SERVICE BULLETIN NO. MSB1078-163/1

ATA-Code: 20-10 Standard Practices - Airframe
 57-10 Wing Structure

G 115C/D/E/EG

Fig.1

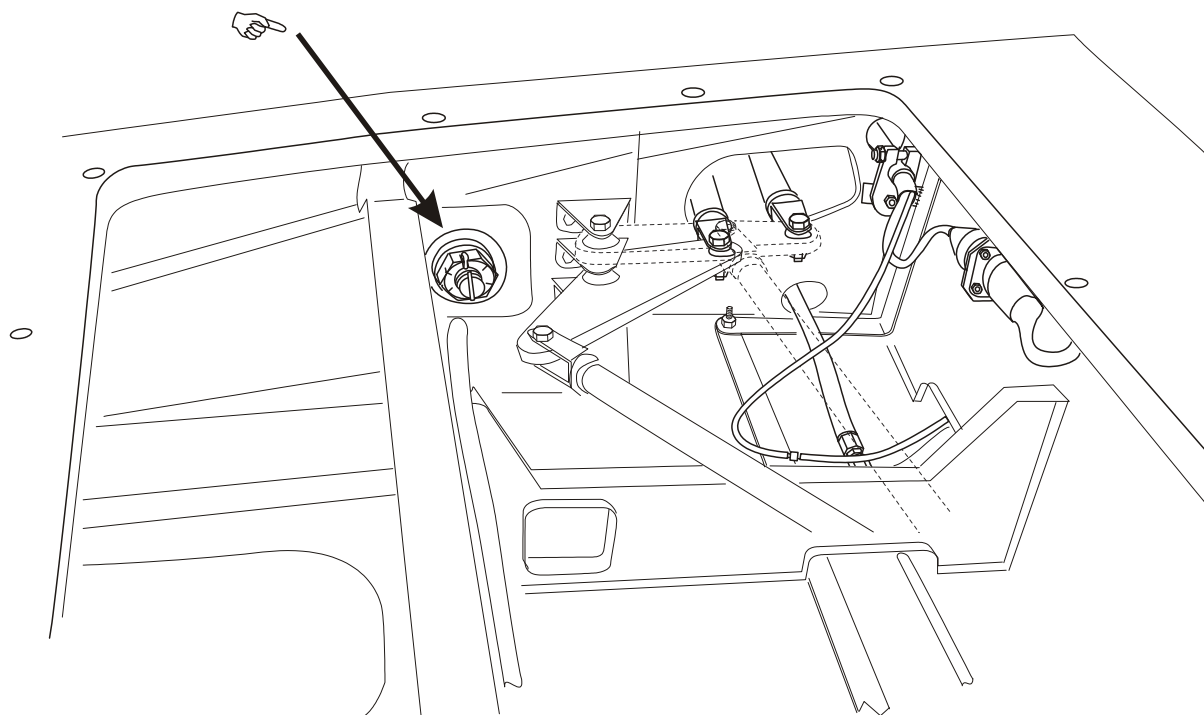
- 1.8.1. Ensure that the aircraft is safe for parking I.A.W. MM chapter 10-10.
- 1.8.2. Remove the baggage compartment panel to get access to the RH and LH rear wing shear bolts (Fig. 1) I.A.W. MM chapter 25-10.

Fig. 2

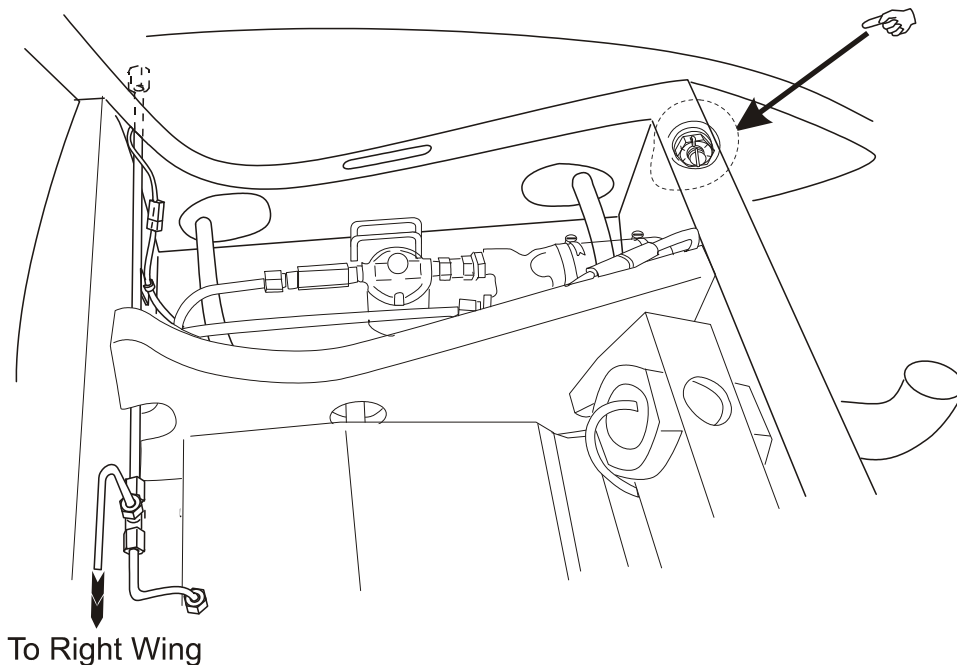
- 1.8.3. Release the cockpit trim panel in front of the pilots seat to get access to the RH and LH front wing shear bolts I.A.W. MM chapter 25-10 (Fig. 2).

Fig. 3

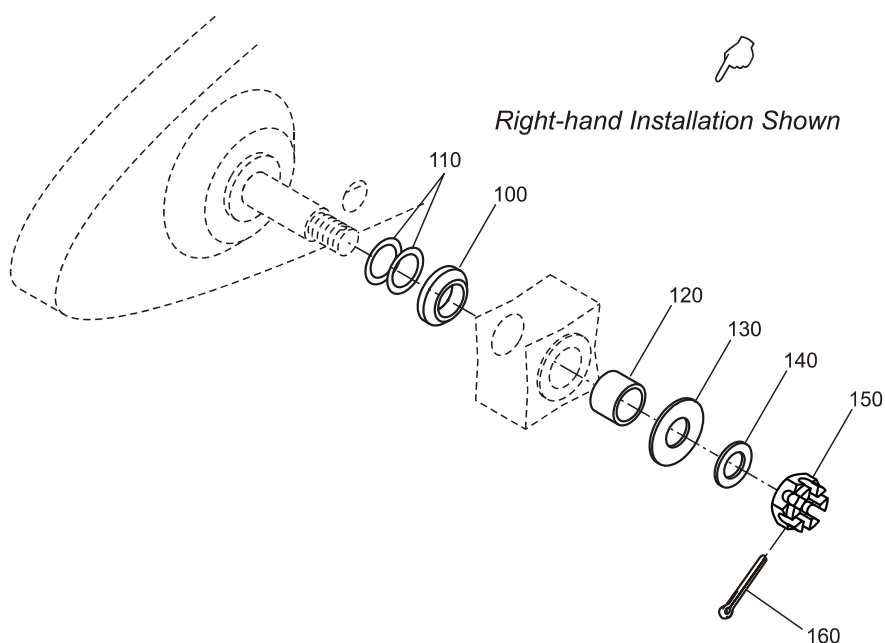
- 1.8.4. Remove cotter pin LN94-4x30 (Fig. 3, item 160) from each wing shear bolt.
- 1.8.5. Release castellated nut P/N LN9345-M16x1,5 (Fig. 3, item 150) as follows:

- turn open both nuts at the LH a half turn
- if washers underneath are turnable, the shimming between wing and fuselage is correct and you may proceed with para. 1.8.6
- if washers underneath is not turnable, proceed as follows:
 - release castellated nuts further stepwise by 1/3 turns until washer is turnable. Note number of 1/3 turns to determine required additional shims (1 whole turn = 1.5mm, thread pitch)
 - remove LH wing I.A.W. MM chapter 57-10
 - install additional shims P/N 115C-1001.28 (Fig. 3, item 110, thickness 0.5mm) between wing and fuselage as required
 - install wing I.A.W. MM chapter 57-10, torque each castellated nut with 20 - 50 Nm (14.75 – 36.87 lbf.ft), note para. 1.9

1.8.8. Install cotter pin LN94-4x30 to each wing shear bolt. If the cotter pin can not be installed within the torque range specified in 1.8.7 use shims P/N DIN 988- 24x17x thickness as required to be placed between the two washers (item 130 and 140).

1.8.7. Torque each castellated nut with 20 - 50 Nm (14.75 – 36.87 lbf.ft).
